ADDENDUM

PROJECT: University of South Dakota
Davidson Building
UPS
Vermillion, South Dakota

AD-1

PROJECT #: 14-0049

PARTIAL BASEMENT FLOOR PLAN

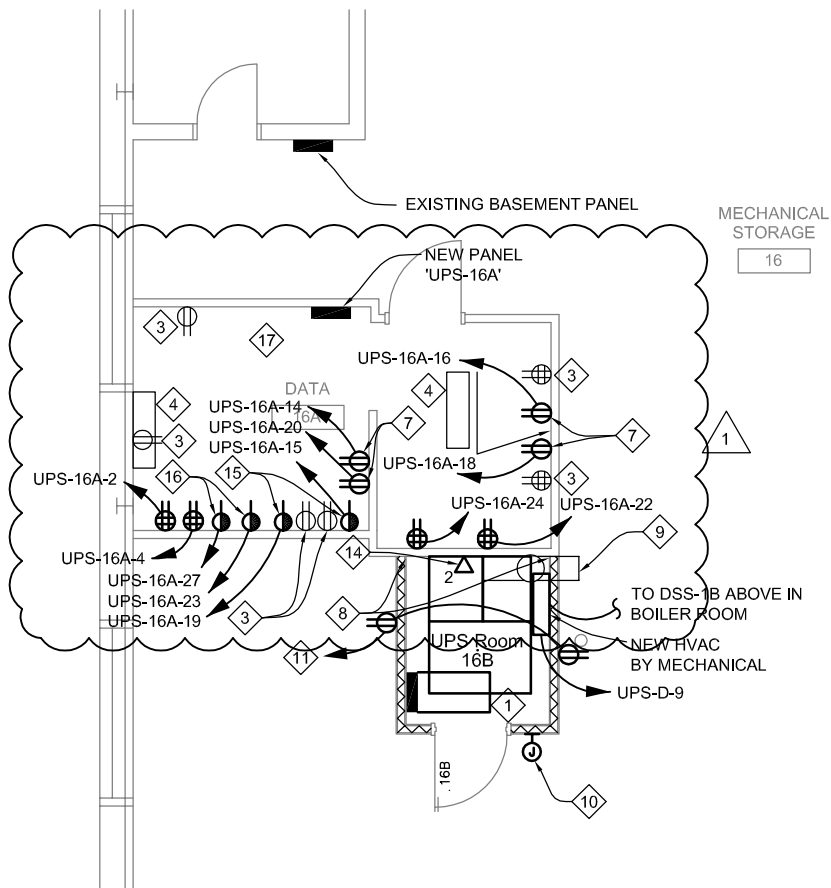
In reference to Sheet E-101, revise Data 16A as indicated in Supplemental Drawing E-101.1 attached.

In reference to Sheet E-101, UPS Room 16B, add duplex receptacle on north wall above UPS and connect to receptacle circuit serving this room.

In reference to Sheet E-101, revise Electrical Keynote '7' reading "Provide NEMA L5-20 receptacle. Coordinate exact location with USD ITS."

In reference to Sheet E-101, add Electrical Keynote '15' reading "Provide NEMA L6-20 receptacle. Coordinate exact location with USD ITS."

In reference to Sheet E-101, add Electrical Keynote '16' reading "Provide NEMA L6-30 receptacle. Coordinate exact location with USD ITS."

In reference to Sheet E-101, add Electrical Keynote '17' reading "Extreme caution must be taken while performing work in this area. Coordinate all installation with USD ITS."
